Historic District Commission

- a) **HDC-26-01 – Major Project Application:** Applicant: St. James Episcopal Church; Owner: Bishop of the Protestant Episcopal Church of NH; Proposed installation of a 54-panel rooftop solar energy system at 44 West St (TMP #575-034-000). Waivers from sec. 22.6.3.C.2 for slate roof replacement with metal and sec. 22.6.3.C.4 for chimney removal are requested. Property is ranked as a Primary Resource in the DT-C District.

STAFF REPORT

HDC-26-1 – 44 West St – Rooftop Solar Energy System

Fig 3: Proposed PV system layout.

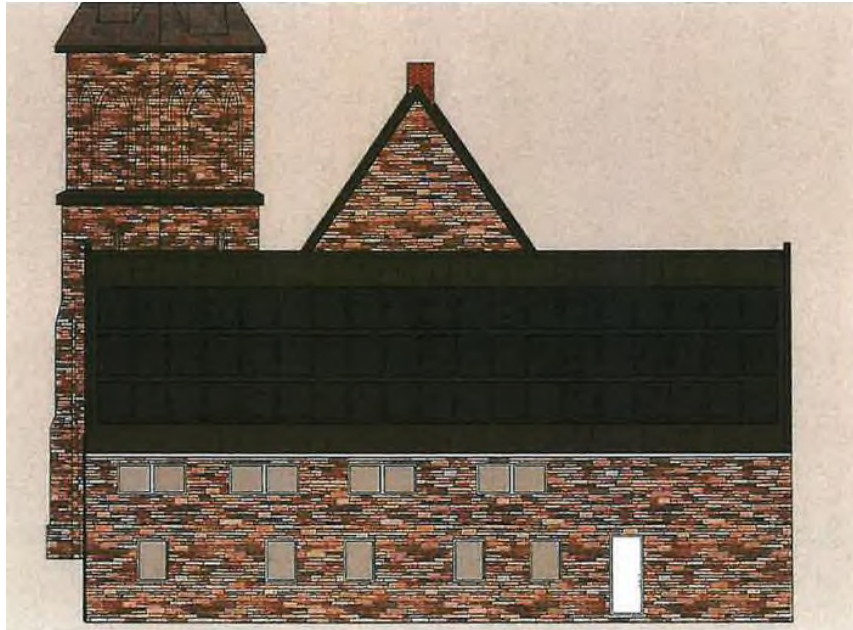
The applicant proposes to install the solar energy system on the southern exposure of parish house roof. This roof is located opposite the front façade of the building which faces West St. Part of this proposal is to remove the existing slate roof and install a standing seam metal roof. The applicant notes that the installer of the solar energy system will not work with the existing slate roof and requests a waiver from this standard to remove the existing slate and replace with a standing metal seam roof, rather than one of the replacement roof materials listed in the regulations.

In addition, the applicant requests a waiver from Sec. 22.6.3.C.4 to remove the existing chimney to make way for the panel layout. The Commission will need to determine if this standard has been met.

The system is proposed to be three rows of 18 panels per row in a uniform pattern. All the panels will be located on a single roof. This standard appears to be met.
